Sonoran Energy Project

(02-AFC-01C)

Data Responses, Set 1 (Responses to Data Requests 1 to 58)

Submitted to
California Energy Commission

Figure DR41-1. Depth to Groundwater

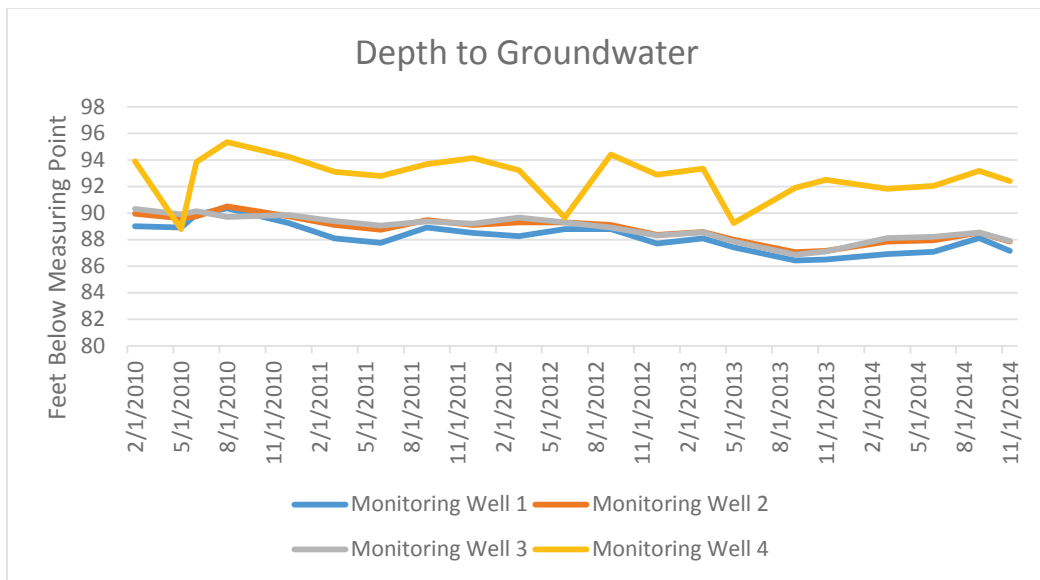
41. Please provide water level data from wells in the site vicinity that show water level trends over the last five years.

Response: Recent groundwater depth information is available from the adjacent Blythe Energy Project (BEP) 1 site – see semi-annual and annual monitoring reports filed with the California Regional Water Quality Control Board, Lahontan Region (RWQCB). Water level data from the last five years are presented in Figures DR41-1 and DR41-2 below (Amec Foster Wheeler, 2015; Amec, 2014; Amec, 2013; Amec, 2012; Amec, 2011). Figure DR41-1 shows water level depth below the ground surface, and Figure DR41-2 shows the potentiometric surface in feet above mean sea level.
